TECHNICAL BULLETIN
JTB00306NAS1
25 JUL 2013

SECTION: 204-02

Suspension 'Knock' / 'Creak' Noise From Rear of Vehicle

F-TYPE (X152)

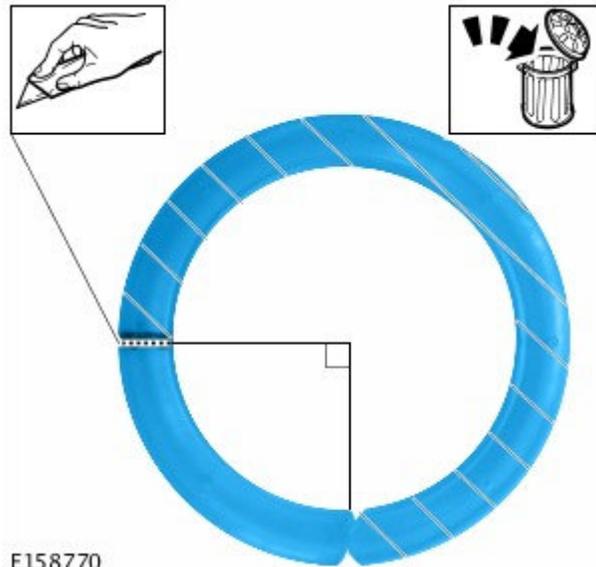
Using one of the new isolator sleeves, cut at the second hole from the end of the isolator sleeve to produce an approximately 90-degree spacer (approximately 100mm in length on the outer circumference); discard the remainder (larger portion) of the isolator sleeve.
